ePIC General meeting

Backward RICH recommendation

John Lajoie and Silvia Dalla Torre

April 14, 2023

n. of Photons per ring
From JLab test beam

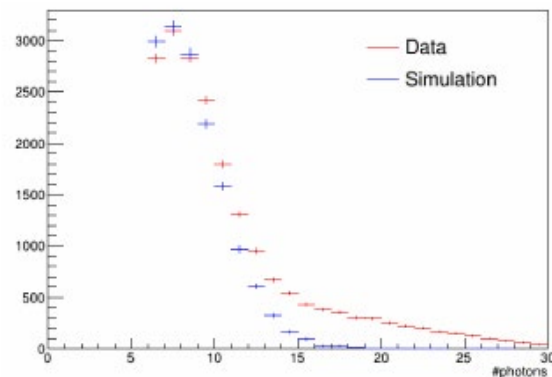
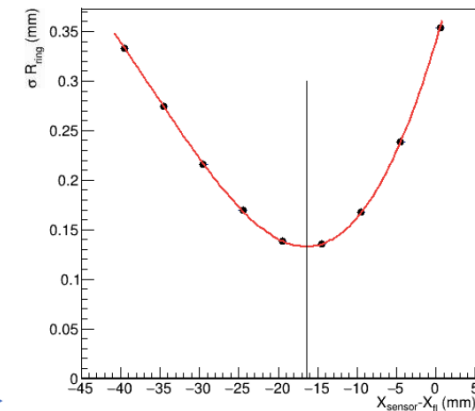
- More photons optimizing the aerogel thickness.
 - Improved resolution claimed with sensor at the focal plane.
- Proving all this requires further R&D.**

QUANTUM EFFICIENCY in SIMULATION STUDIES

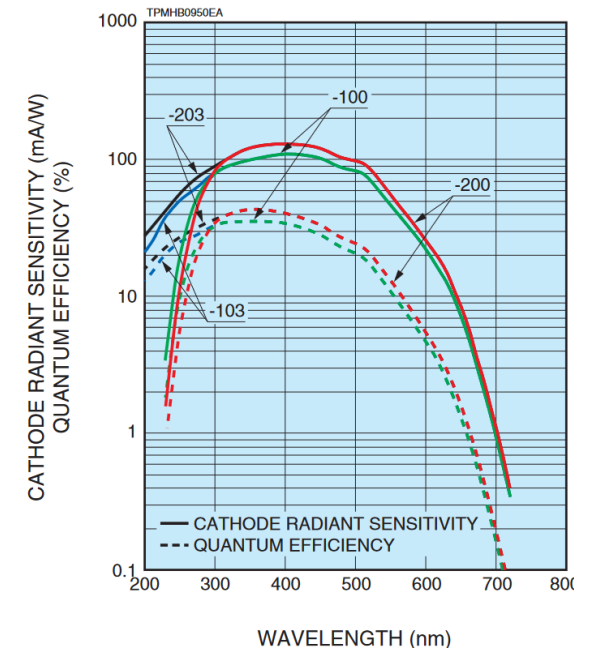
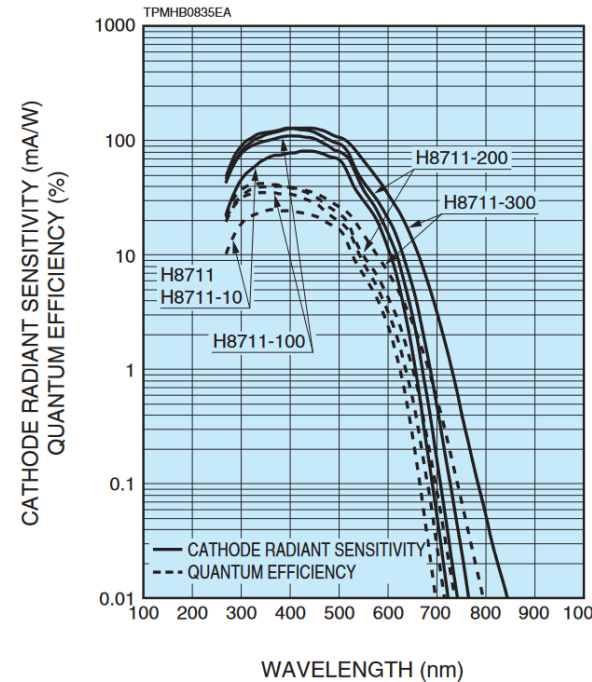
We did, however, implement an accurate digitization reflecting the pixelization as well as Q.E. but shifted the Q.E. distribution to start above 350 nm but with a maximum value of 38% at ~500 nm which has a similar distribution in shape to LAPPD.

A photocathode with QE~ 38% at 500 nm is not at hands. Hamamatsu reference plot copied here (more examples available in literature).

any possible R&D dedicated to the development and engineering of a different photocathode would have a time-scale incompatible with the project timelines (90% readiness for CD3)

Impact from backward PID envelopes on dp/p from tracking

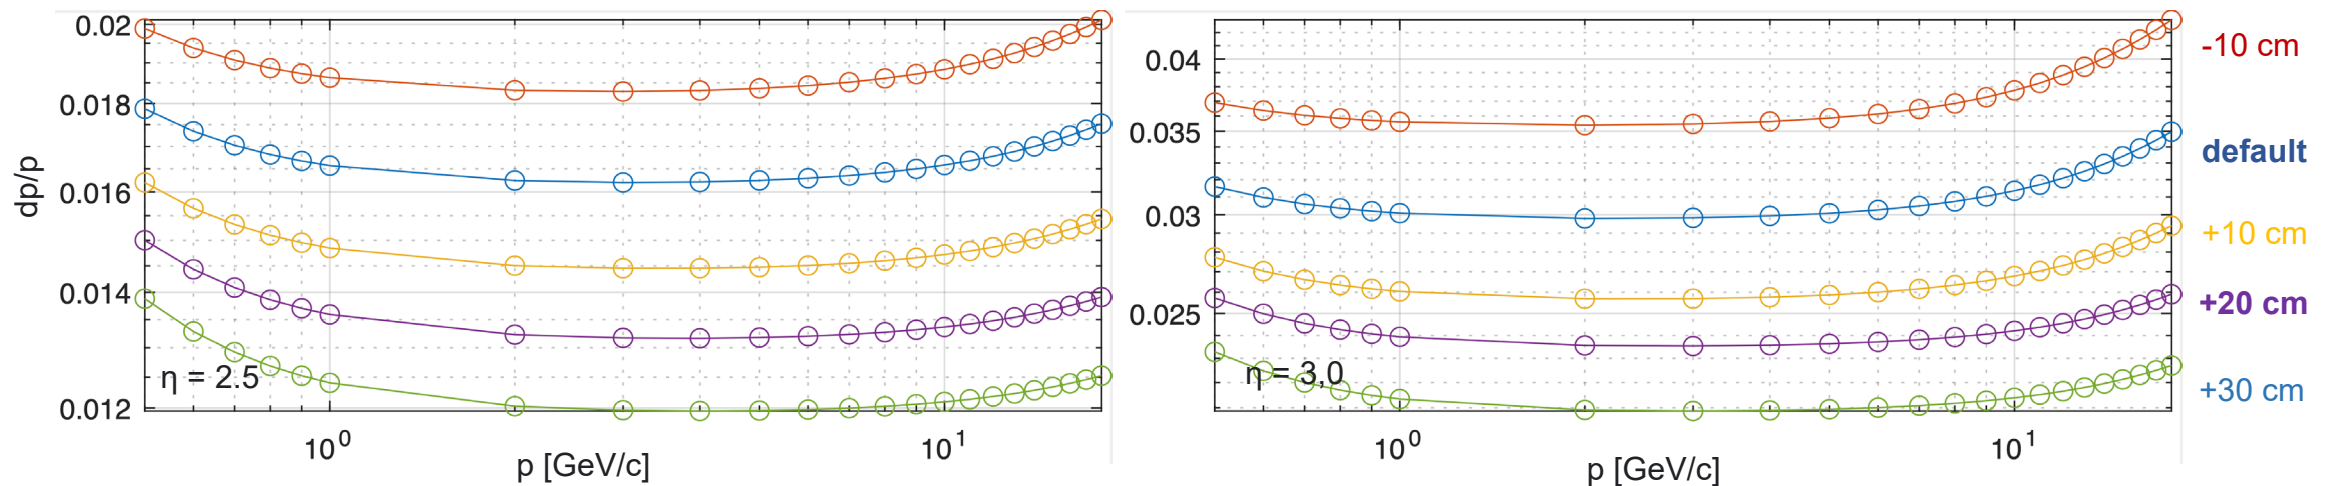
pfRICH about 25 cm longer → impact on the resolution provided by tracking

The envelope of the backward PID system affects the space available for tracking,

The reference MAPS implementation respects the pFRICH envelope in its default form; the mRICH envelope is anticipated to be smaller, thus leaving more space for tracking,

It is thus meaningful to ask what effect additional or reduced space has on dp/p resolution,

An increase in lever arm is clearly beneficial to momentum resolution, but this does not scale as L^2 as would be expected from point resolution alone due to multiple scattering. The physics impact of this loss or gain in dp/p is not assessed here.

Approaching the performance in a realistic environment

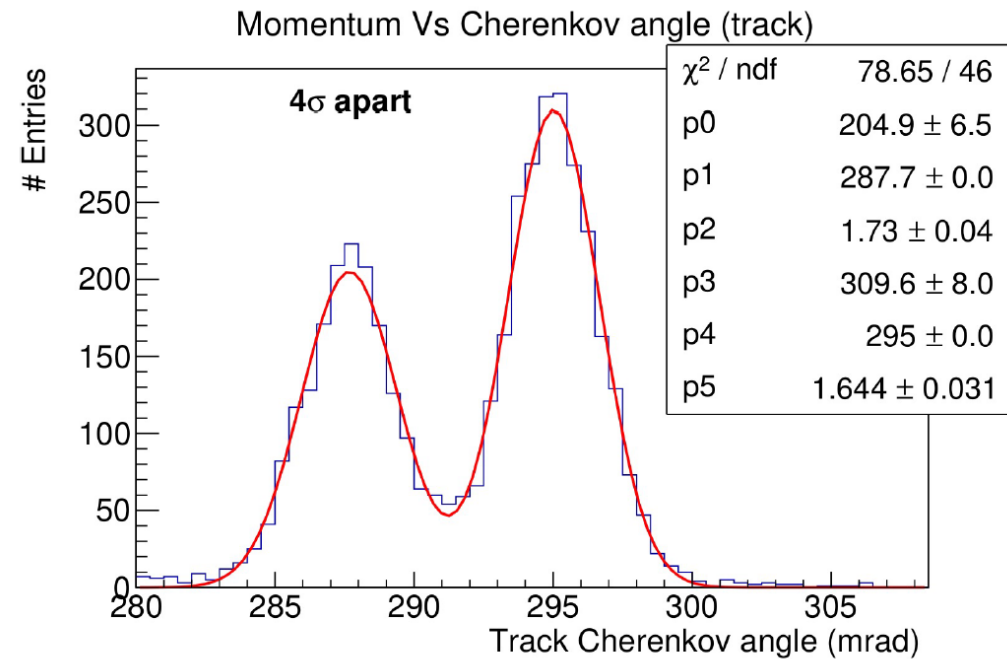
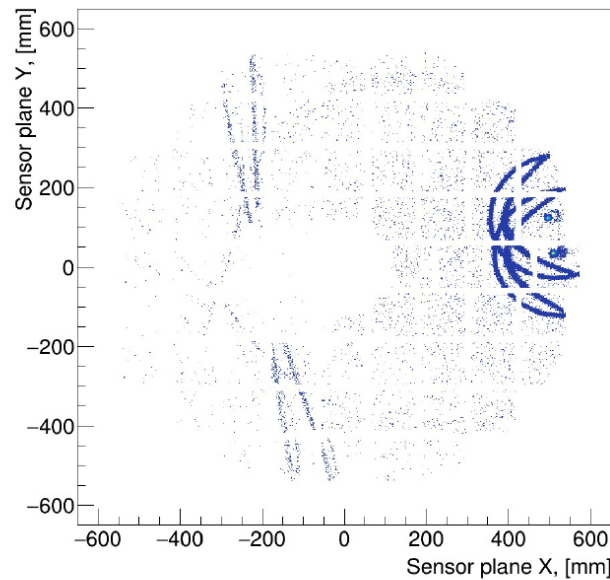
No double particle studies available, either in test beam or by simulations

pfRICH can separate extreme multi-particle cases

- π and kaon generated in same event.
- particle ϕ angle chosen to have overlapping rings at border pseudorapidity
- Event-based χ^2 model has a **95% accuracy** separating multi-particles
